Independent Review of Glint and Glare Assessment

Proposed Wagga Wagga South Solar Farm at 157
Windmill Road, Bomen, NSW 2650

September, 2020

Figure 5 Excluded receptors

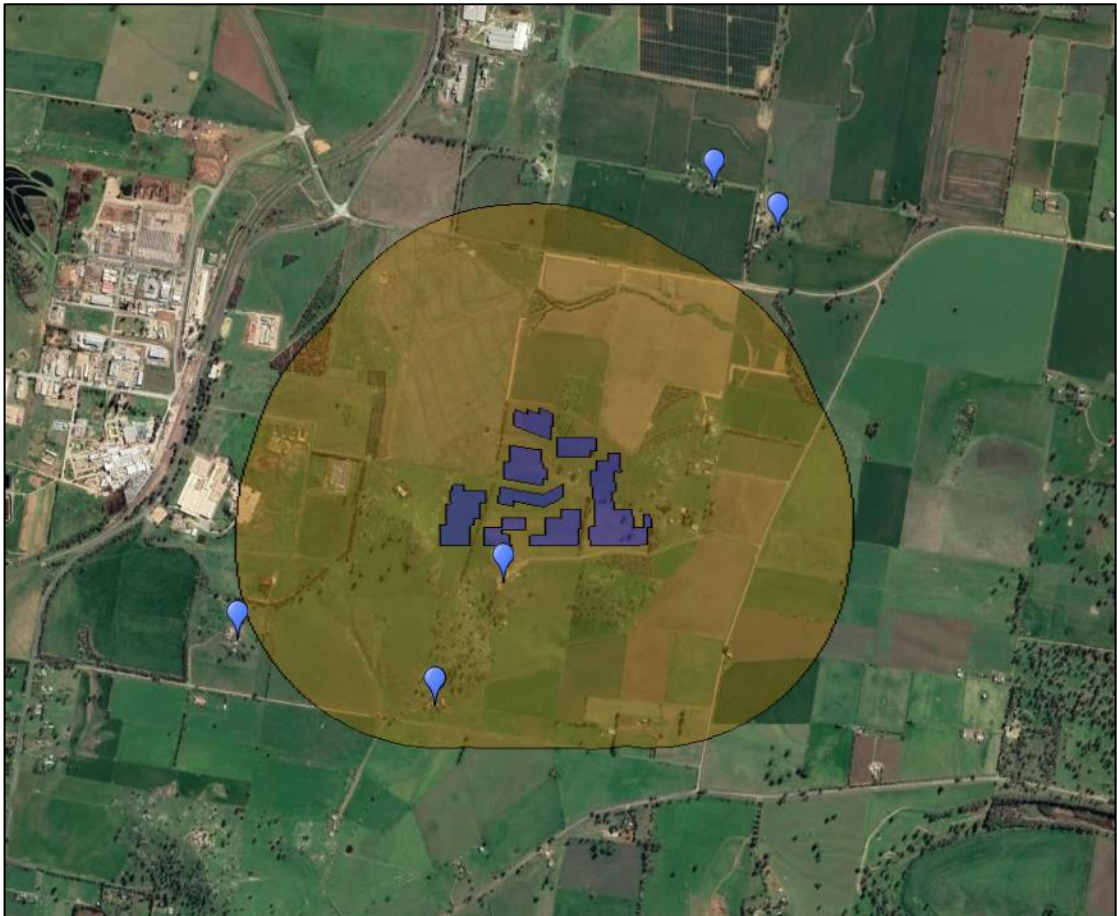
One of the excluded properties close to the southern boundary appears to be denoted as a landholder property within the Visual Amenity Assessment. In addition, some of these are very close to assessed receptor points which provide representative results for receptors in the general area.
